From: Medak, Christine <christine_medak@fws.gov>
Sent: Wednesday, September 14, 2016 1:17 PM
To: GYU@dpw.lacounty.gov
Cc: Rogers, Bonnie L SPL; Mari (Schroeder) Quillman; Vargas, Jessica M SPL; Chirdon, Matthew@Wildlife; Jonathan Snyder
Subject: Review of On-Site Mitigation Hydrology Justification
Attachments: Appendix_D_hydrology-report_small.pdf

Devil's Gate Sediment Removal and Management Plan
On-Site Mitigation Hydrology Justification

Well Monitoring Locations

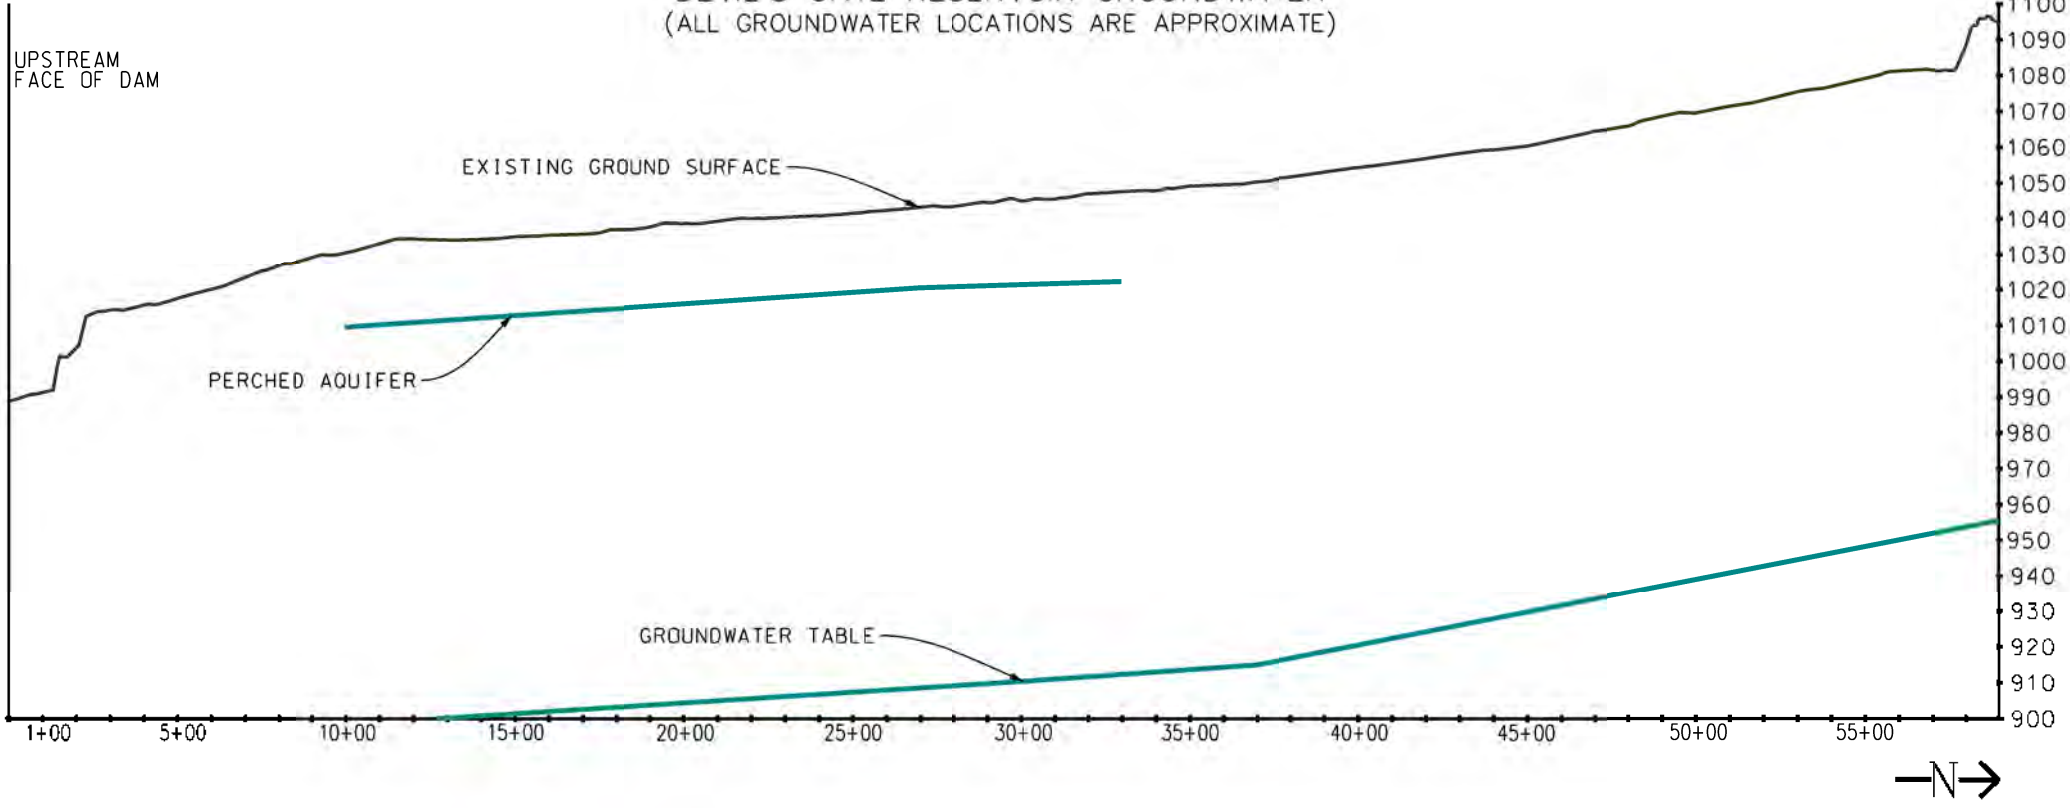
- 2) Information provided in Attachments 5 and 6 of the Justification compares groundwater elevations over time and at various sediment levels within the reservoir. What is the source of the data provided in these graphs? Monitoring wells located on the east side of the reservoir are depicted in Attachment 4 but it is not clear if these wells were used to generate the graphs in Attachments 5 and 6. Is it possible that wells located on the east side of the spreading basins record artificially high groundwater levels due to the adjacent City of Pasadena spreading basins that are located above the elevation of the reservoir? If so, these wells may not detect changes in groundwater levels compared to sediment levels in the Reservoir. It appears the spreading basins are regularly maintained so the elevation of adjacent groundwater should be fairly stable.

Reservoir Capacity vs. Groundwater Levels

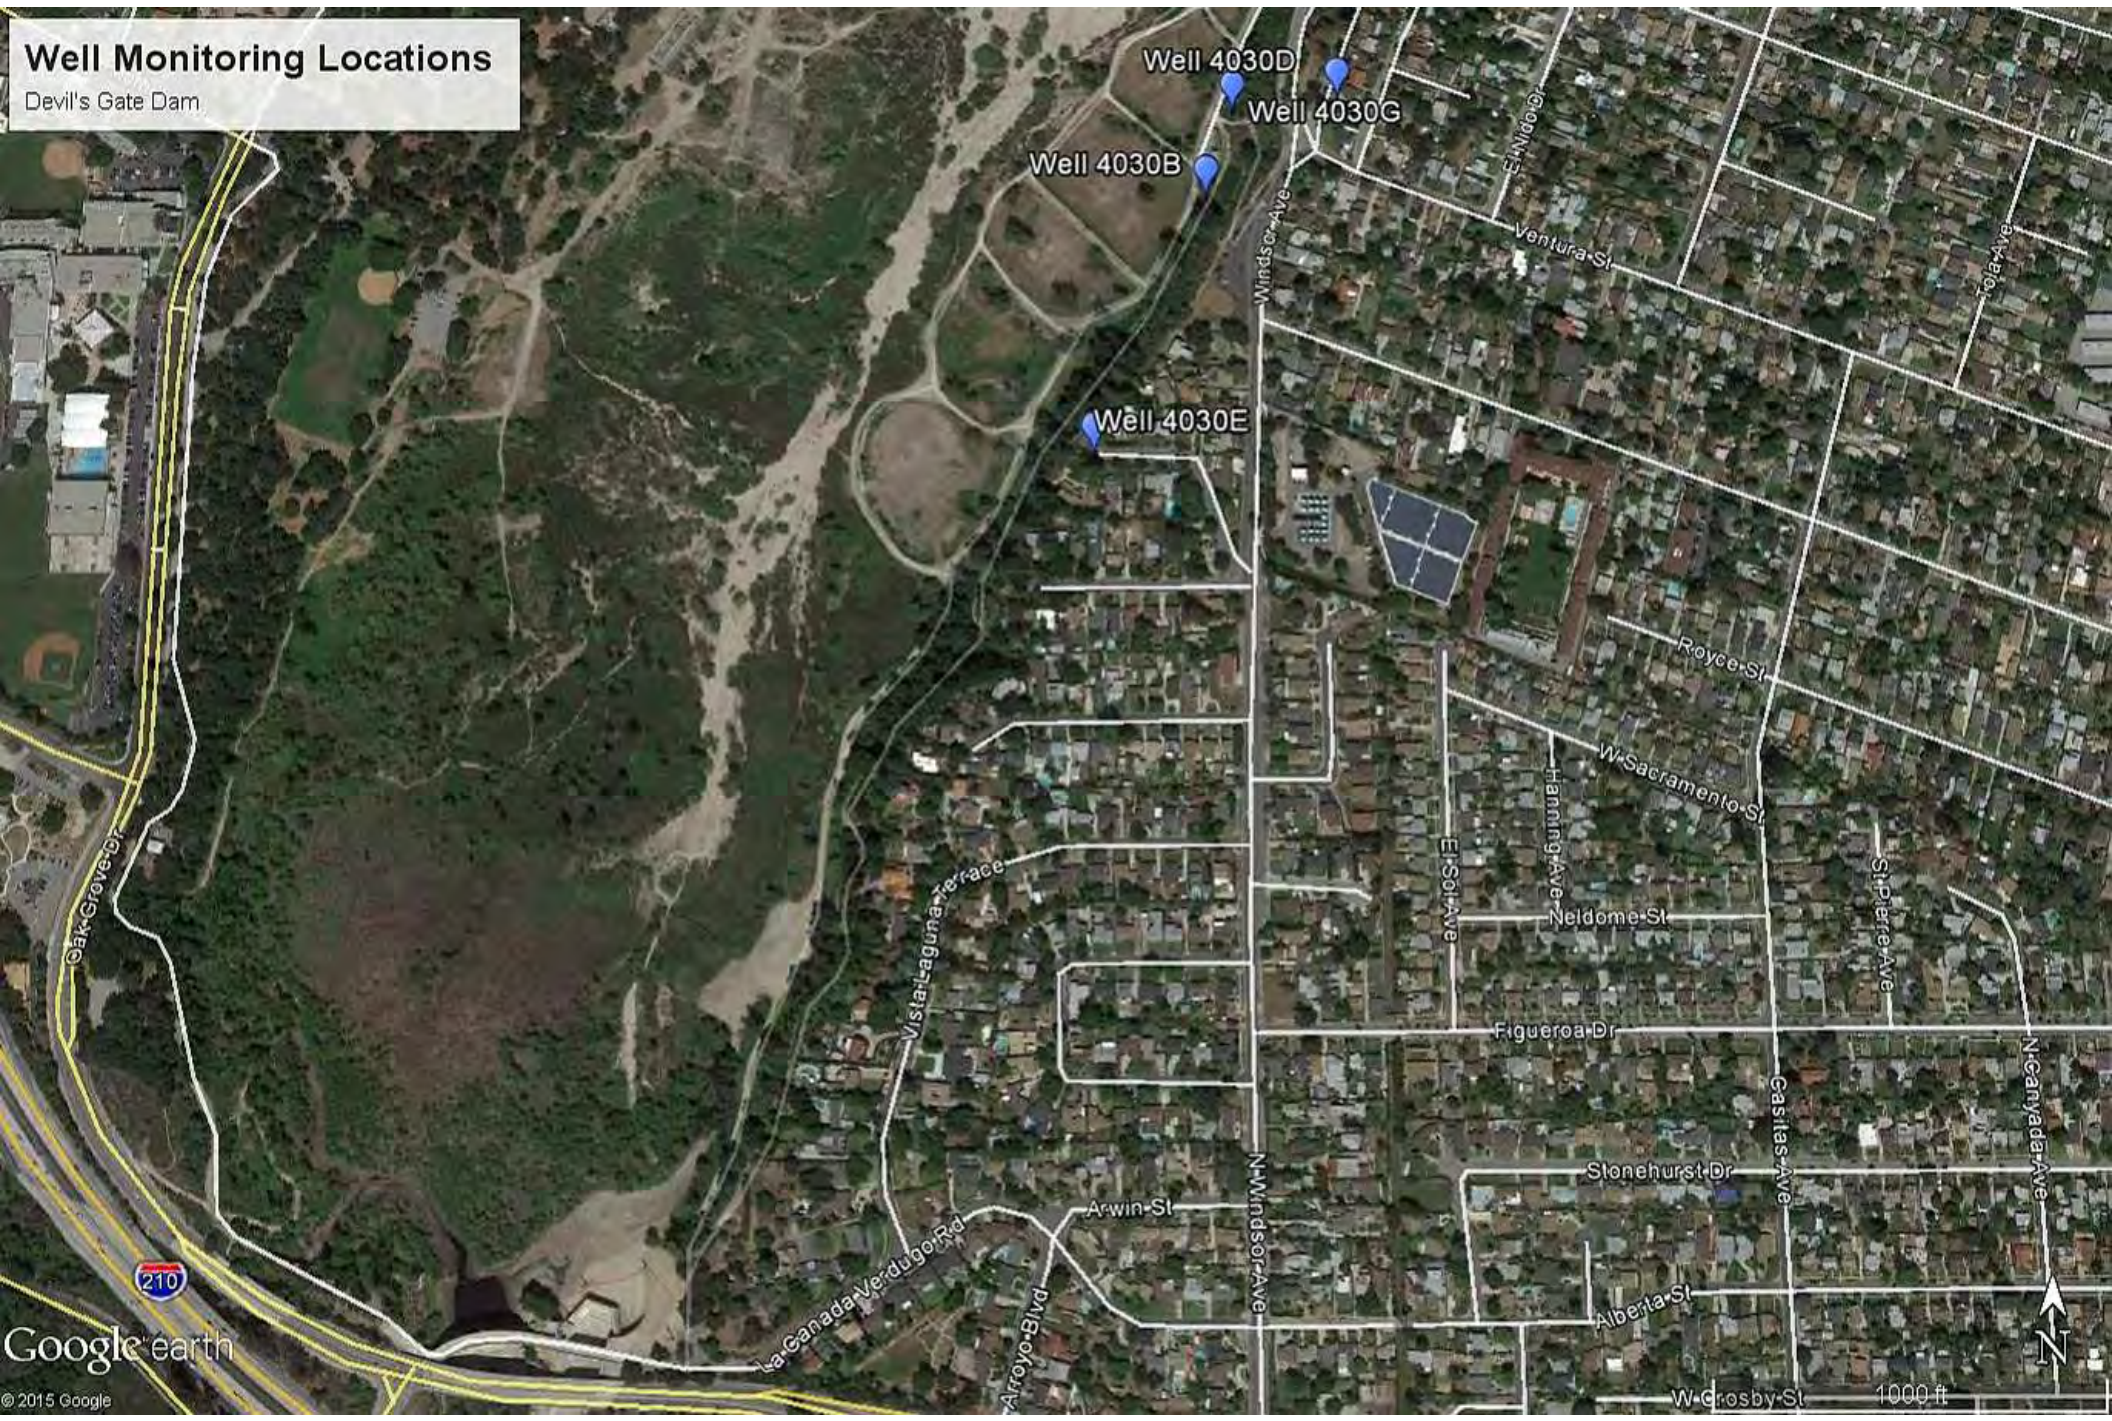
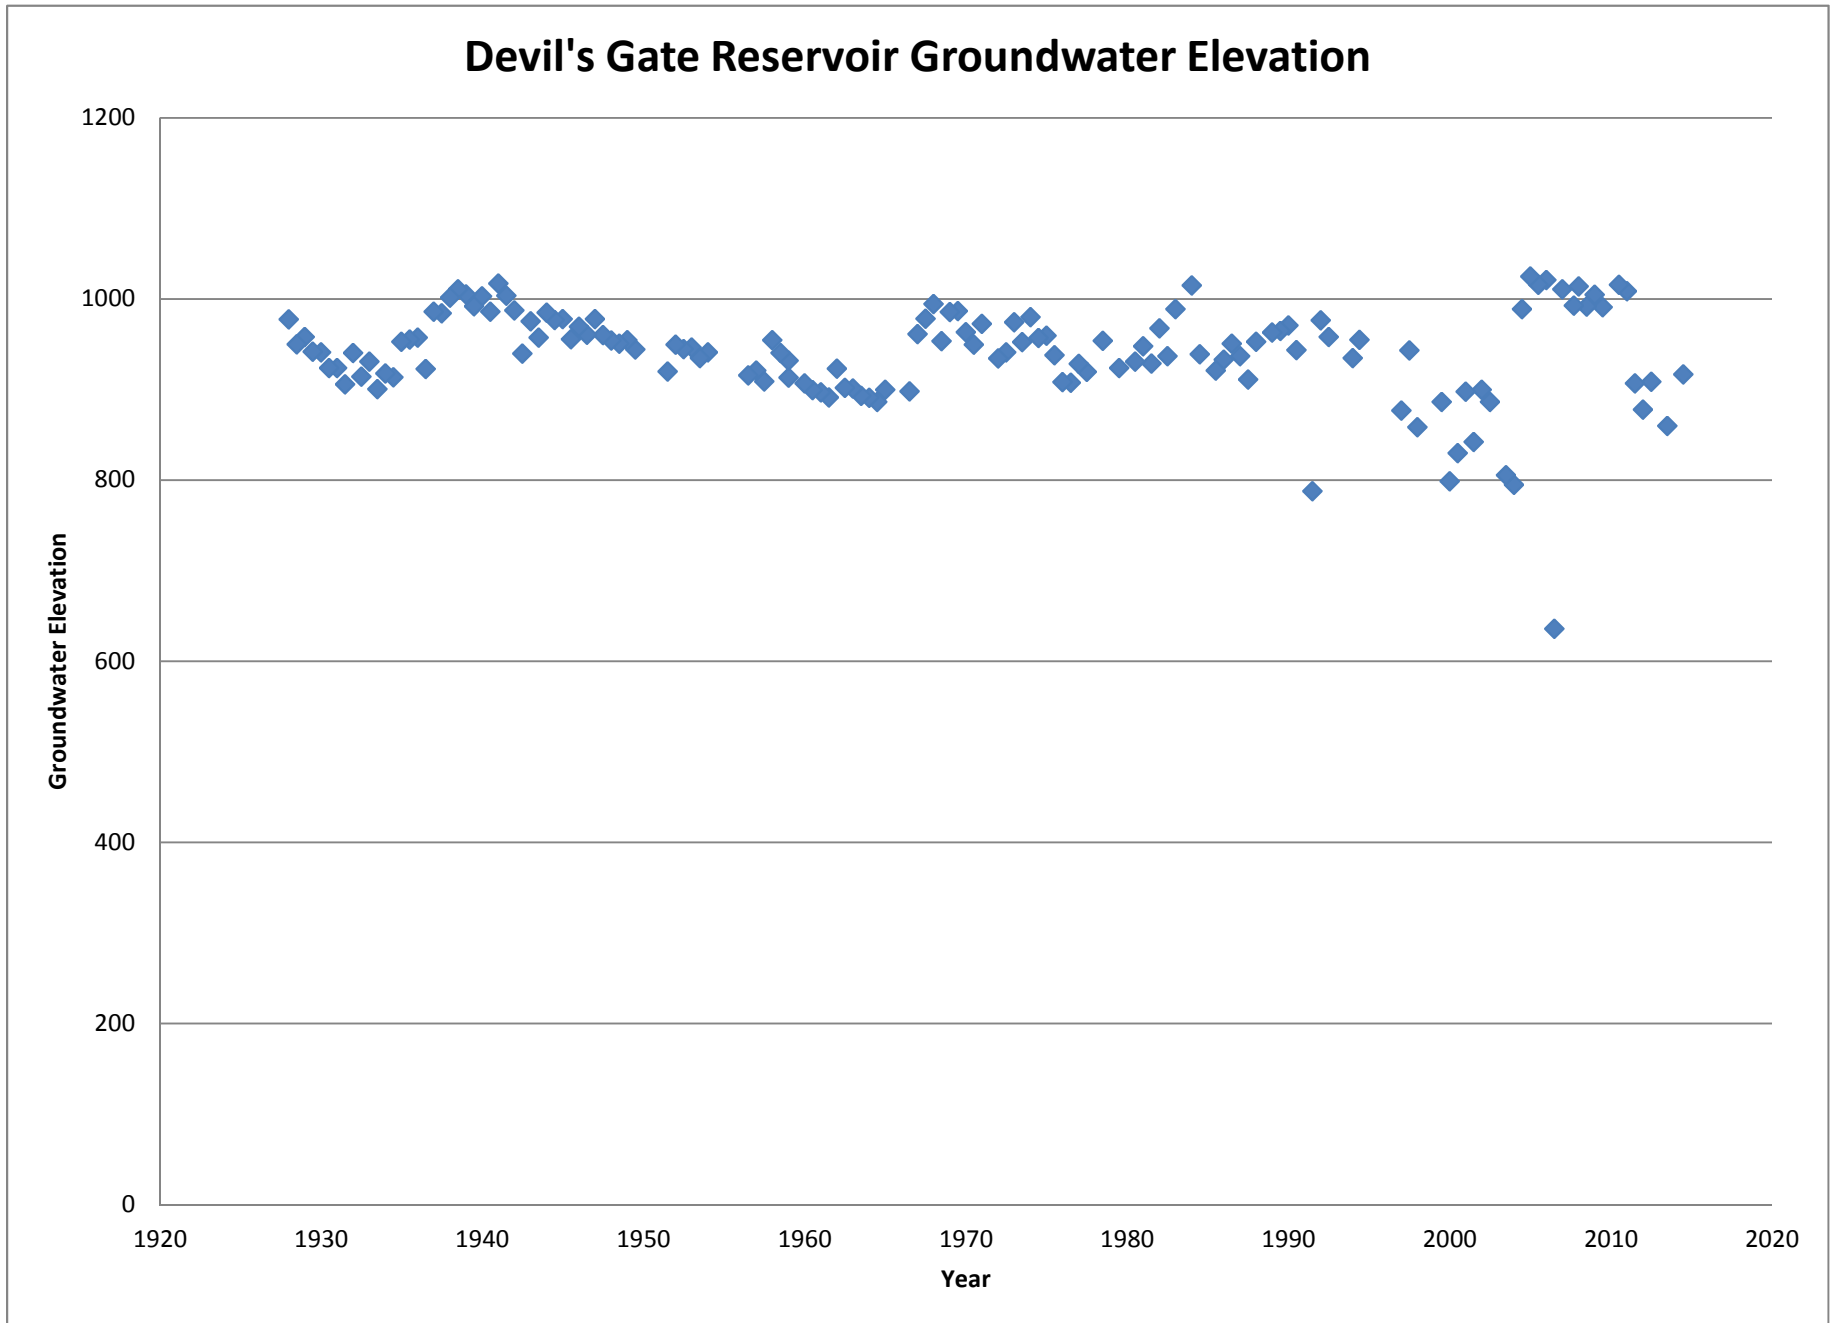
- 3) In Attachment 6, the graph displays reservoir capacity below 1054'; however, the spillway was lowered to 1040.5' in 1997. What is the source of the data? Does this graph include data prior to 1997 (i.e., when more water could be held)? What is the relevance of capacity above the spillway elevation?

**DEVIL'S GATE DAM RESERVOIR
DEVIL'S GATE RESERVOIR SEDIMENT REMOVAL PROJECT**

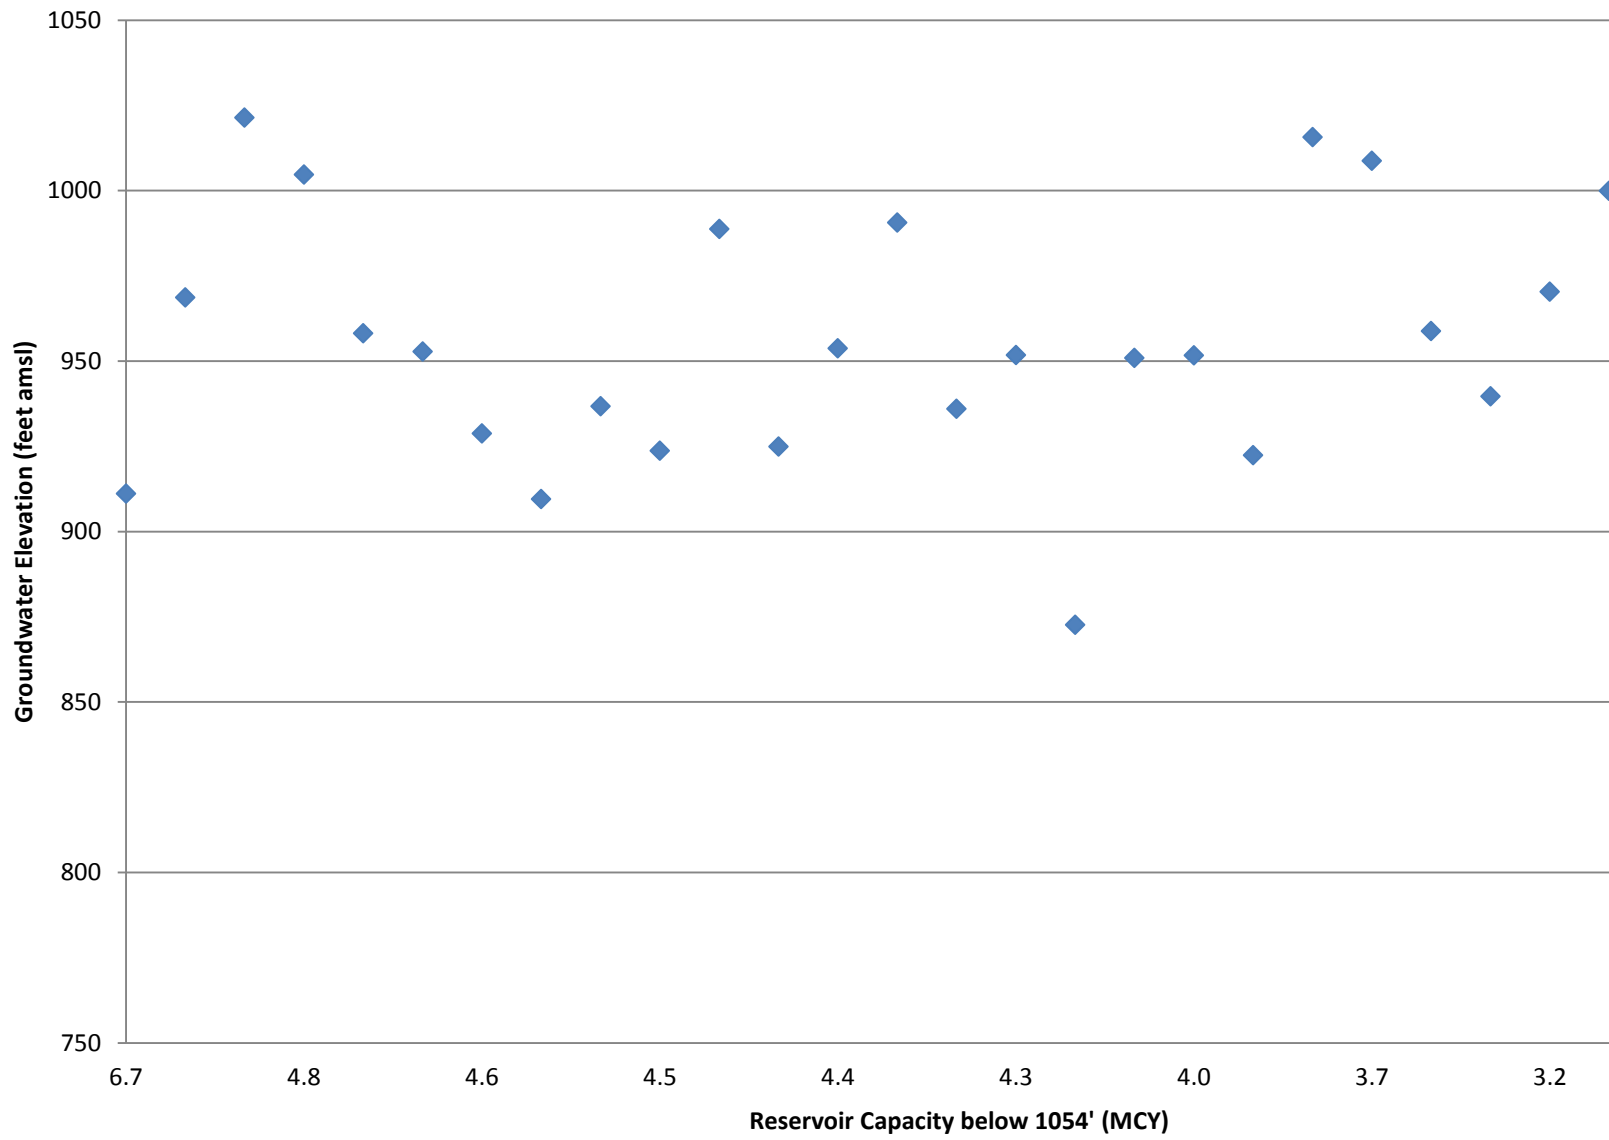
5) In attachment 7, what is the relevance of the 2009 water capacity? How does this compare with the current condition?
